Provide new Security Fencing in several locations within the Bricklight District Parking areas. Update Parking requirement calculations to align with current IDO guidelines, Add additional parking lot lighting, and a new pole sign located at the western vehicular access off of Yale Ave.

RE: Minor Amendment to Site Development Plan-Project Number 1004927, from August 17, 2006

project file  
**Bricklight Courtyards**  
Lots 6-10, 17-21, Block 1, University Heights  
Albuquerque, New Mexico  
sheet title  
**Site Development Plan for Building Permit**

Bricklight Courtyards  
Site Plan Revisions for  
Administrative  
Amendment

A1 Site Plan for Administrative Amendment  
1"=20'-0"

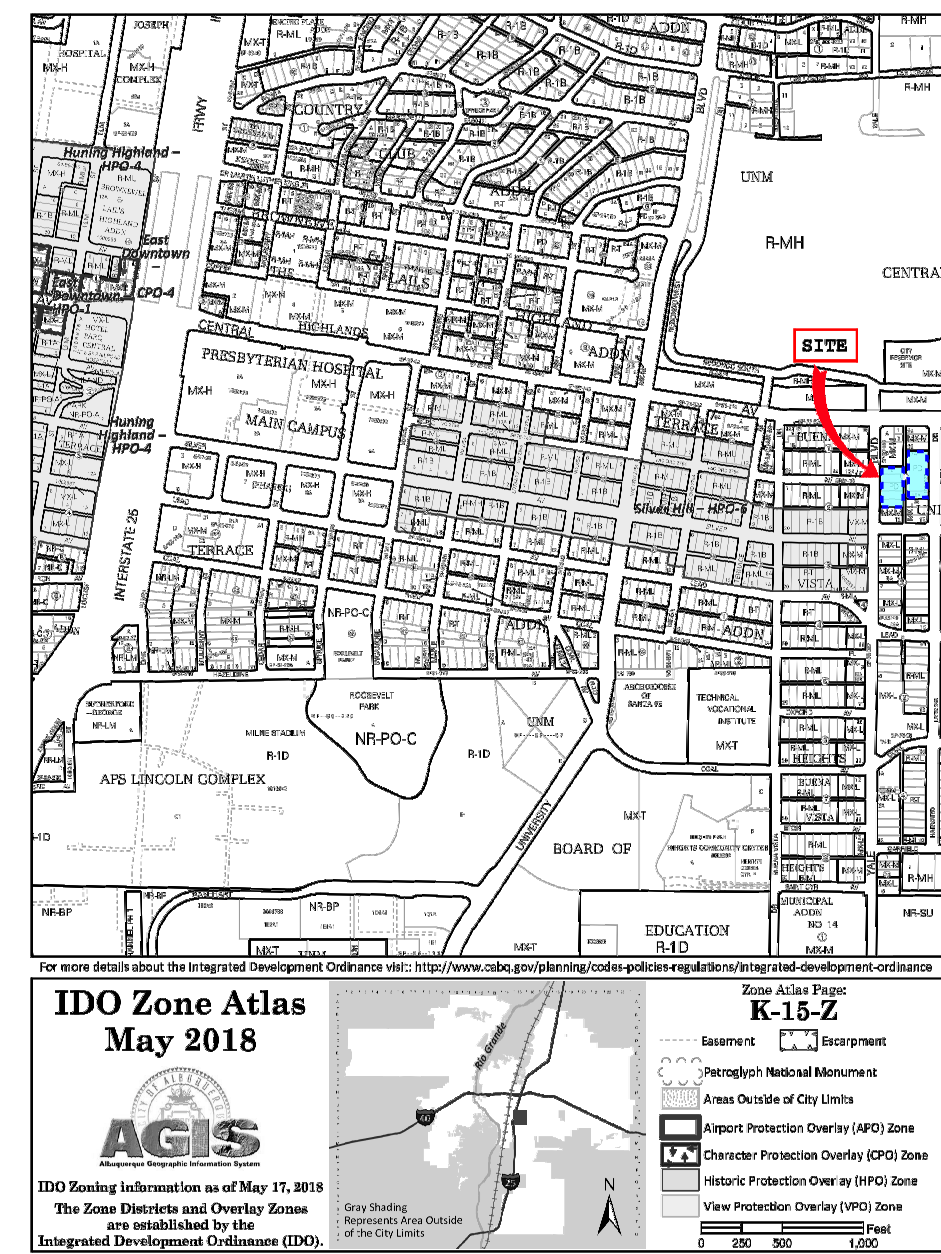
- A. THE PURPOSE OF THIS MINOR ADMINISTRATIVE AMENDMENT IS TO MAKE REVISIONS TO THE EXISTING PARKING LOT LOCATED AT SOUTHWEST SIDE OF THE EXISTING SITE DEVELOPMENT PLAN. REVISIONS INCLUDE THE FOLLOWING:

- PROPOSES A NEW 6'-0" TALL DESIGN MASTER (SEE ATTACHED CUT SHEET) SECURITY FENCE ALONG THE ALLEY WAY LOCATED JUST WEST OF THE BRICKLIGHT COURTYARD APARTMENTS. SEE SITE PLAN FOR LOCATION.

- PROPOSES NEW 6'-0" TALL DESIGN MASTER SECURITY FENCE ON THE EAST SIDE OF THE EXISTING 36" TALL STUCCO WALL ALONG YALE. SEE SITE PLAN FOR LOCATION. SEE VARIANCE REQUEST NUMBER PR-2022-007708.

- PROPOSES A NEW POST SIGN CONSISTENT WITH THE IDO REQUIREMENTS FOR THE VEHICULAR ACCESS POINT ON YALE AVE. SIGN TO BE A MAXIMUM OF 26'-0" TALL.
  - PROPOSES (2) NEW LIGHT POSTS AT THE CENTER OF THE PARKING LOT IN ORDER TO INCREASE SITE VISIBILITY AND SECURITY AFTER DARK. THE PROPOSED LIGHT POSTS AND STRING LIGHTING SHALL CONFORM TO THE REQUIREMENTS SET FORTH IN THE CURRENT VERSION OF THE IDO SECTION 14-16-5-8 OUTDOOR AND SITE LIGHTING. MAXIMUM HEIGHT 20'-0". SEE SUBMITTED PLAN FOR LOCATIONS.

# CLASSIC

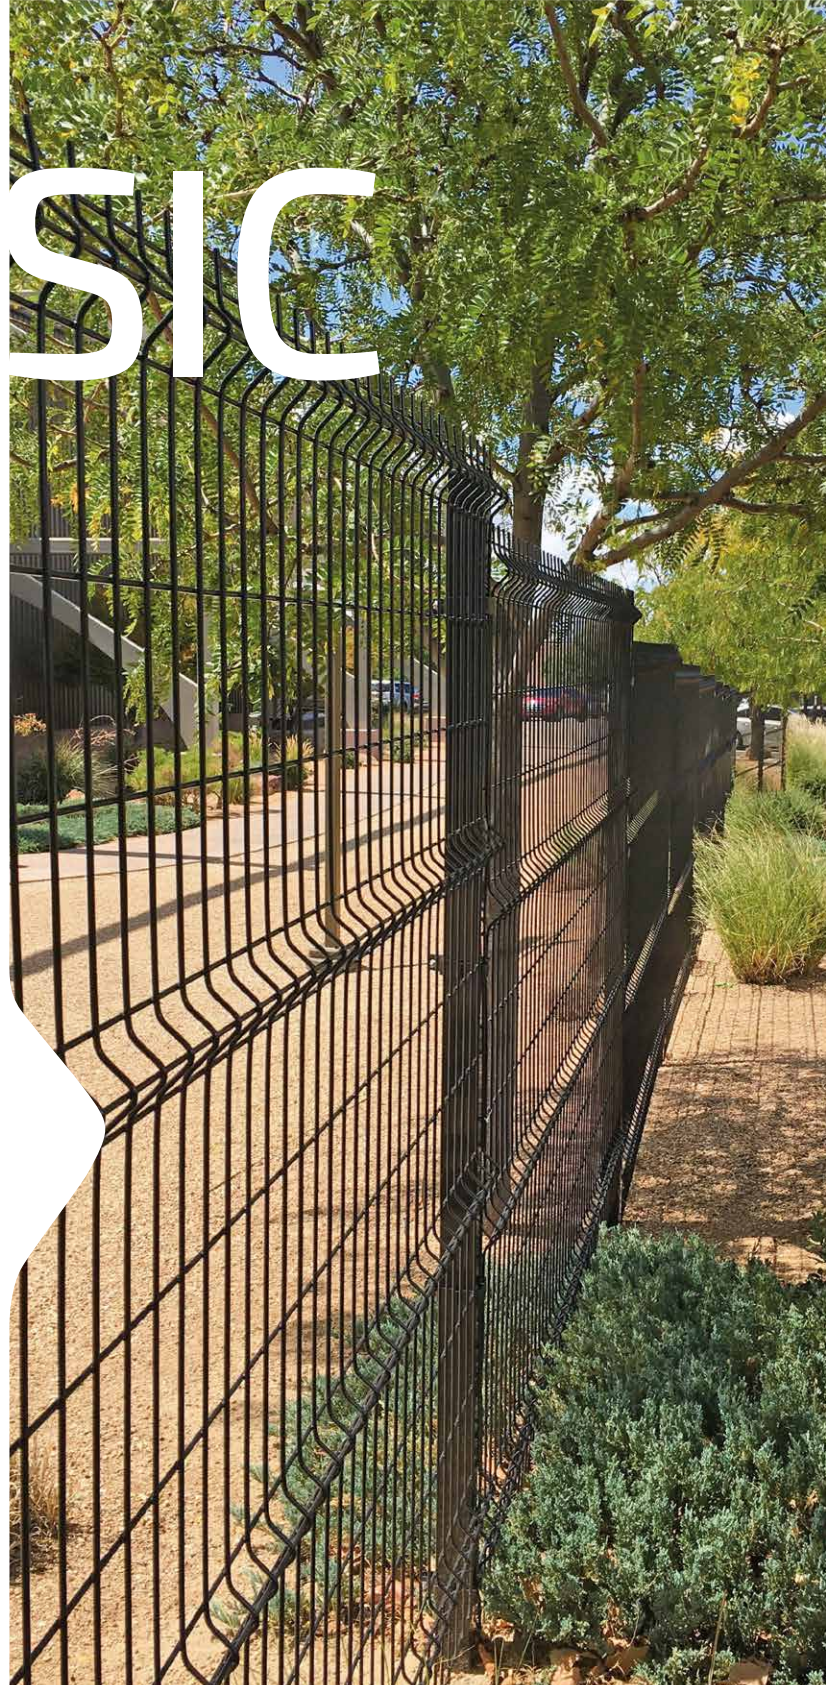
Proposed fence to be 6'-0" tall  
finish to be black powder coat
